CONVAIR

COMMERCIAL CHANGE PROPOSAL

SPEC NO.: ZD- 22-321

CUSTOMER: AVENSA

INTERIOR SEATING ARRANGEMENT

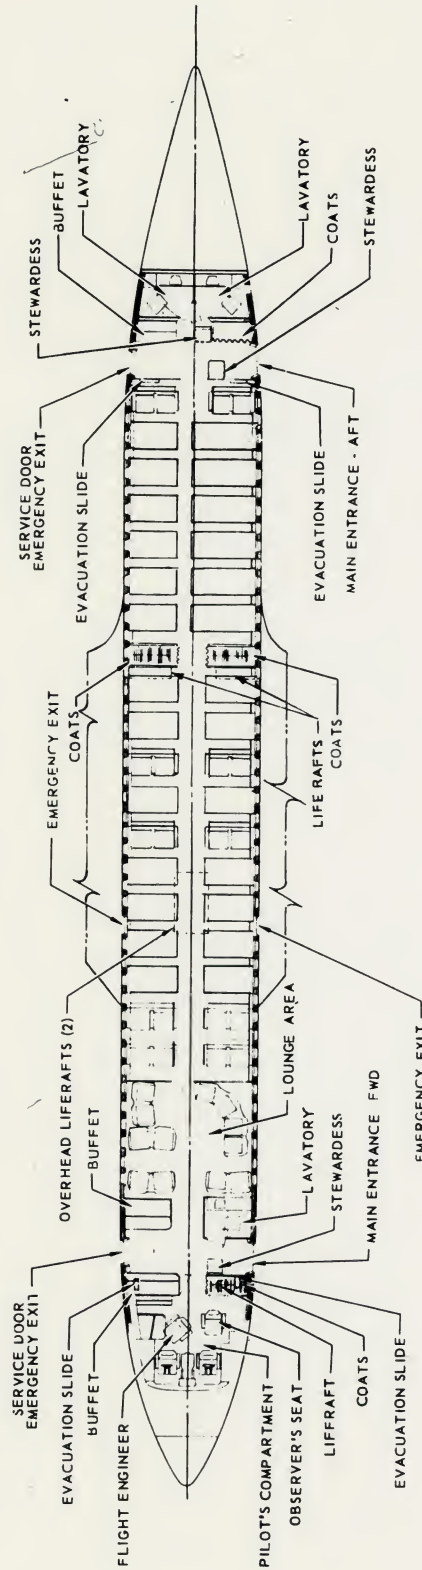
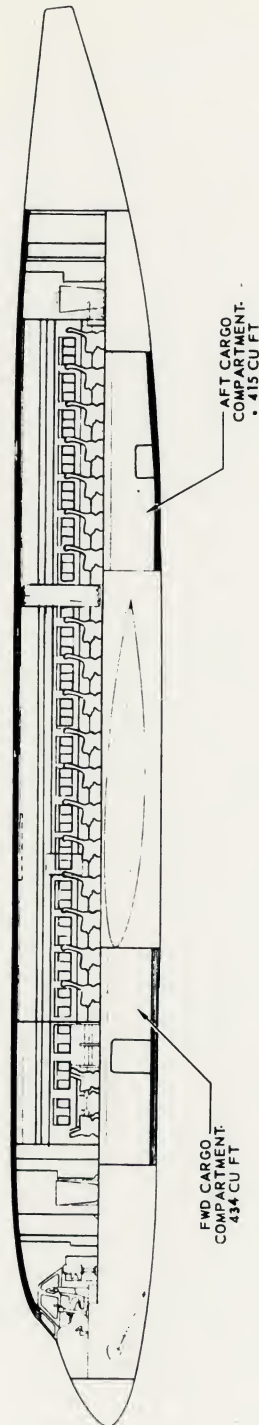
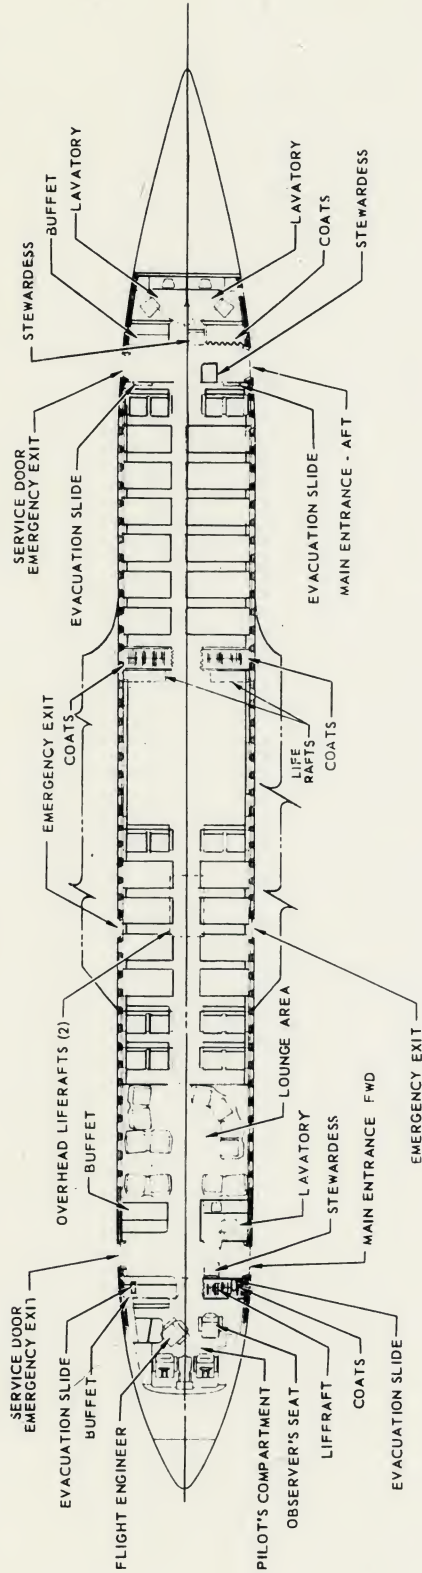
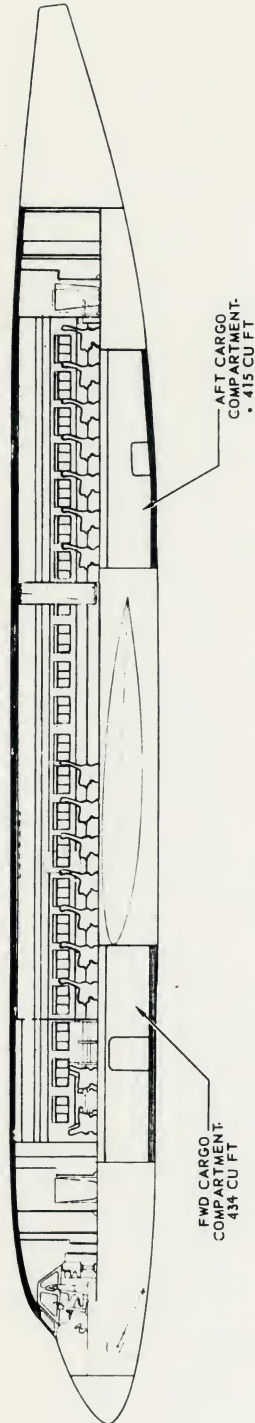
Replace above illustration in the specification with Enclosure (A) which indicates that this illustration is applicable to No. 1 Airplane only.

Add above page (Enclosure (B)) to the specification, which is identified as applicable to No. 2 Airplane.

To: "The standard interior arrangements of these airplanes shall be as shown on "Page 3b - INTERIOR SEATING ARRANGEMENT" for No. 1 Airplane, and "Page 3c - INTERIOR SEATING ARRANGEMENT" for No. 2 Airplane."

GENERAL ARRANGEMENT

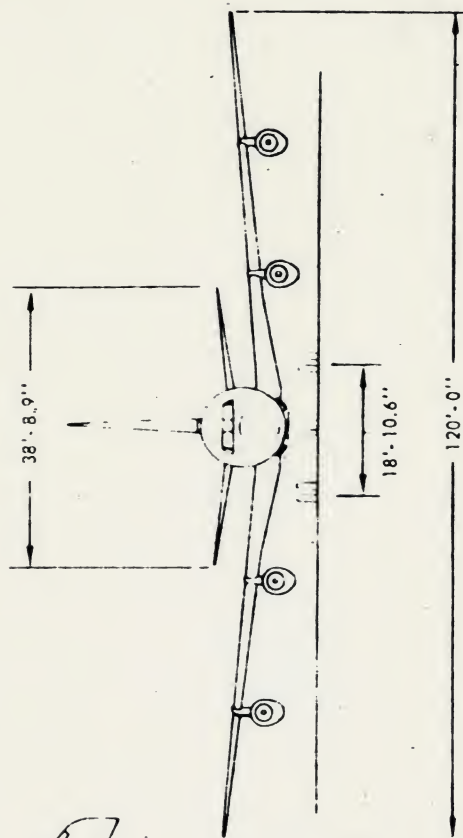
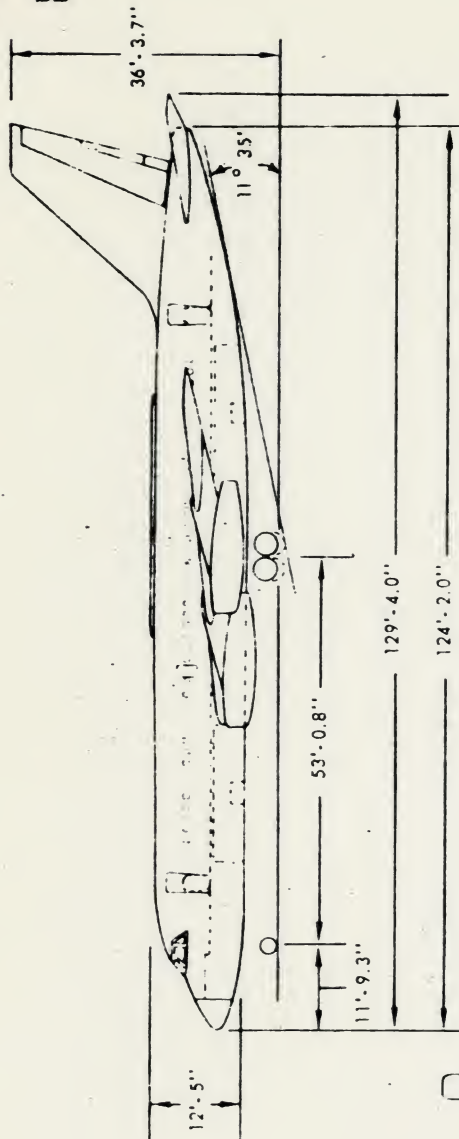
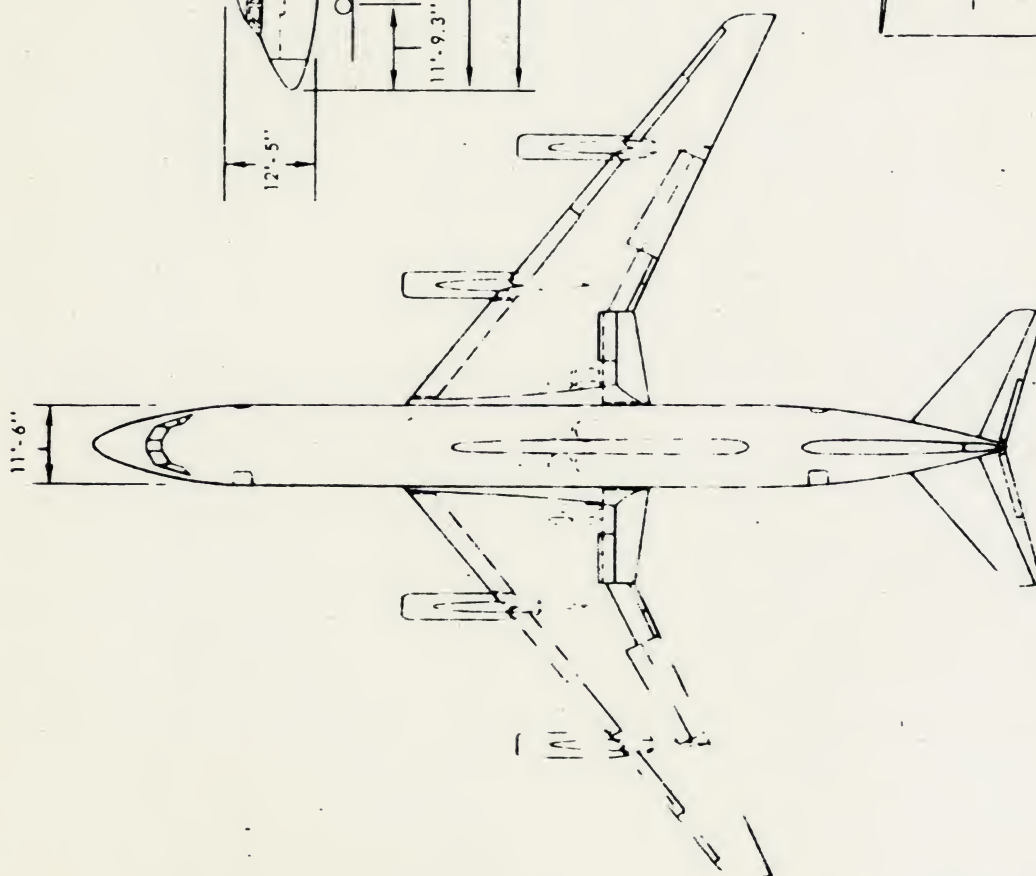
Replace above illustration in the specification with Enclosure (A) which shows Krueger Flap installation between inboard pylon and fuselage, and trailing edge inboard flap extension.

Enclosure (A) One copy Page 45a - PITOT STATIC SYSTEM (Revised)

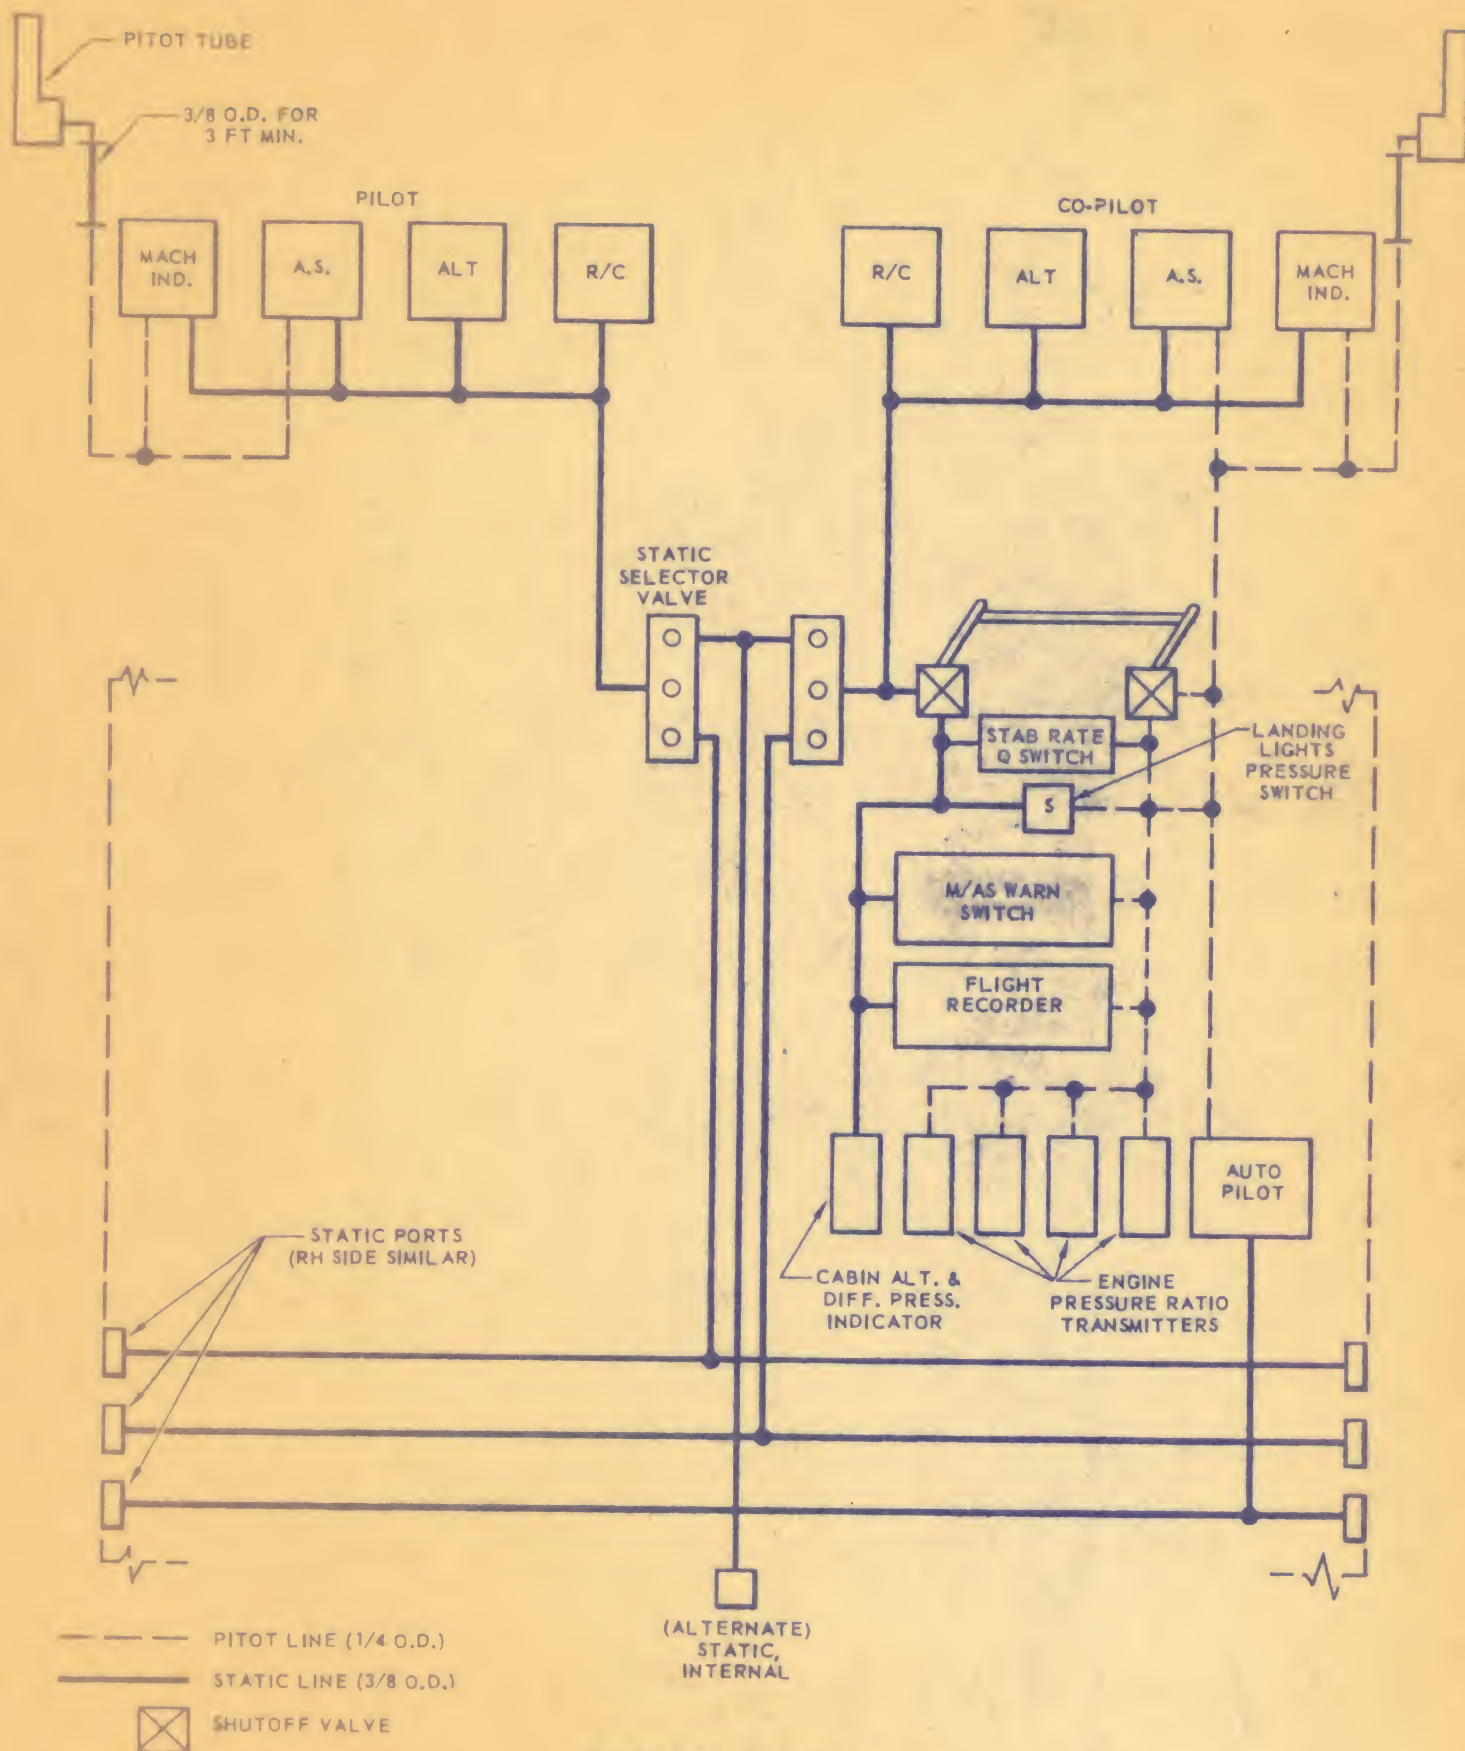
Replace above illustration in the specification with Enclosure (A) which shows Flight Data Recorder installed.

Enclosure: (A) One copy Page 44a - PILOT'S AND COPILOT'S CONSOLE
AND WING PANELS (Revised)

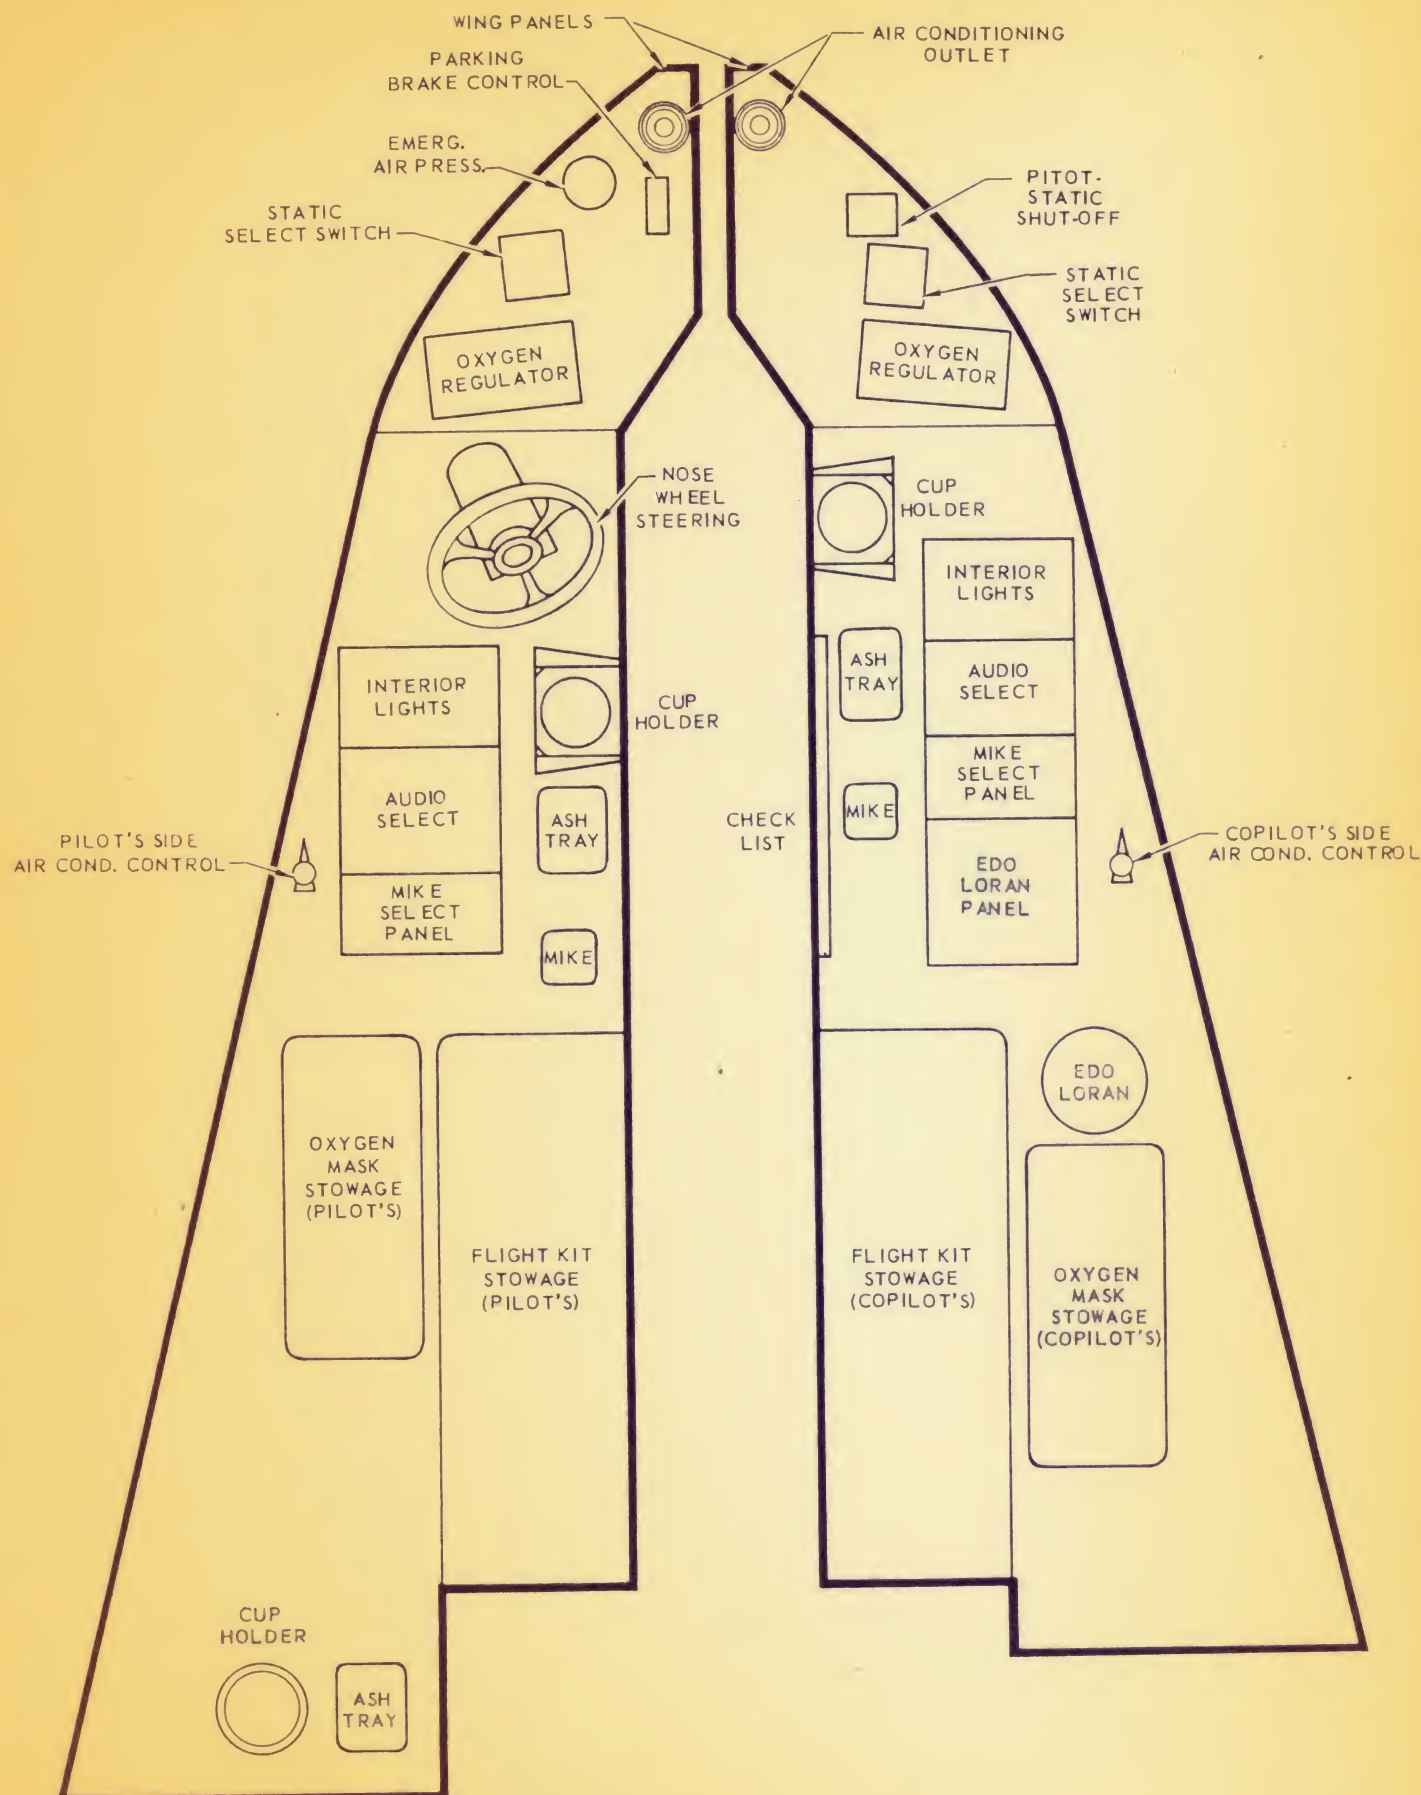
Replace above illustration in specification with Enclosure (A) which shows "Edo Loran" and relocates copilot's oxygen mask stowage.

Enclosure: (A) One copy Page 43a - PILOT'S AND COPILOT'S INSTRUMENT PANELS (Revised)

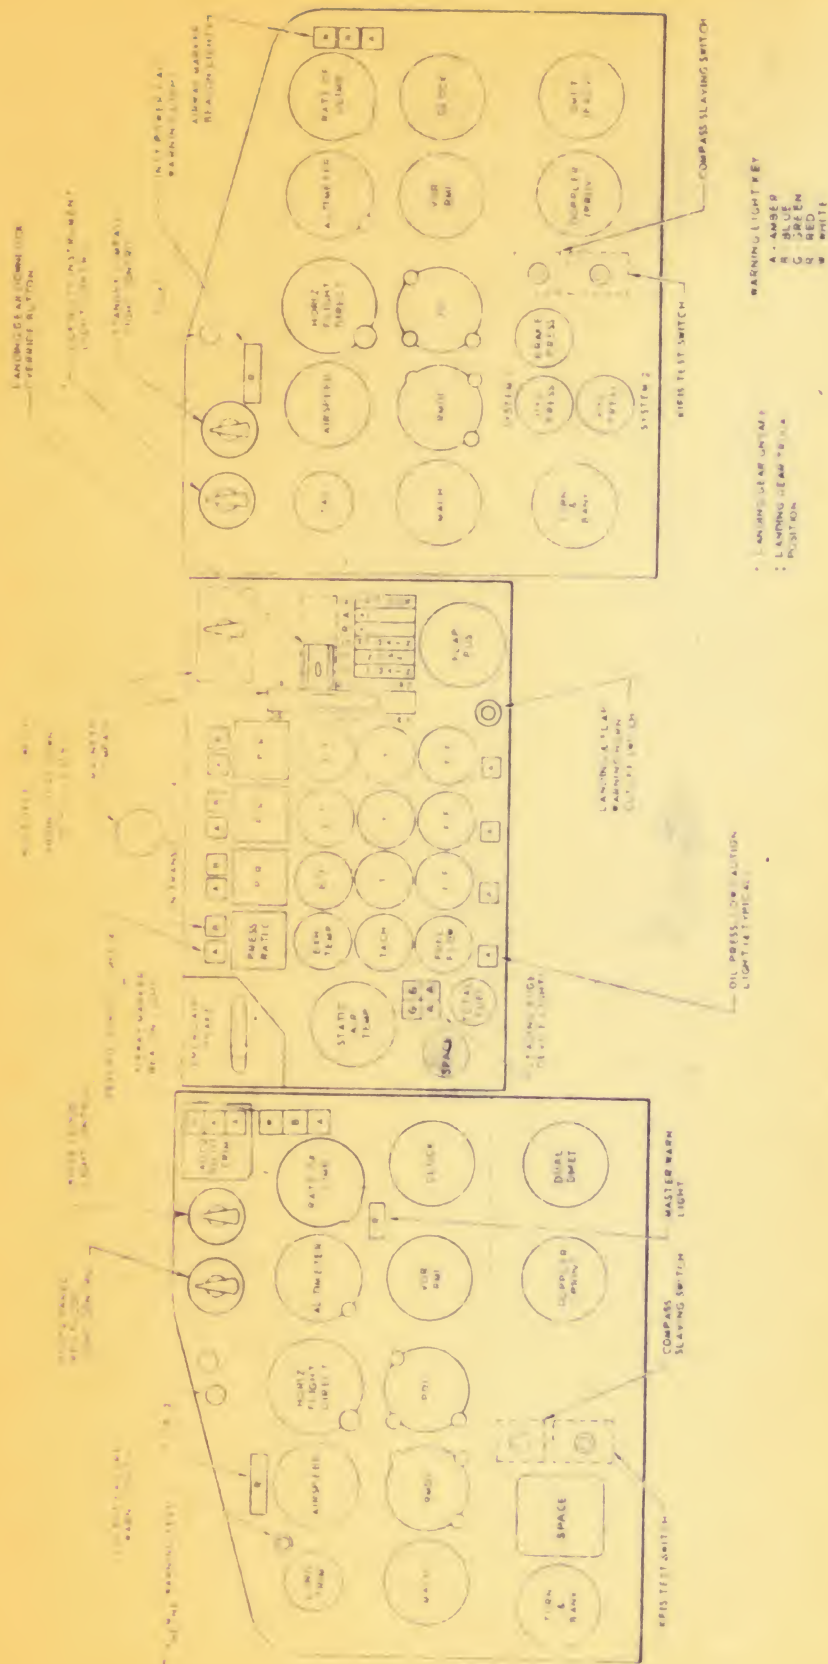
Replace above illustration in the specification with Enclosure (A) which corrects the fuse callout on Pilot's and Copilot's panels.
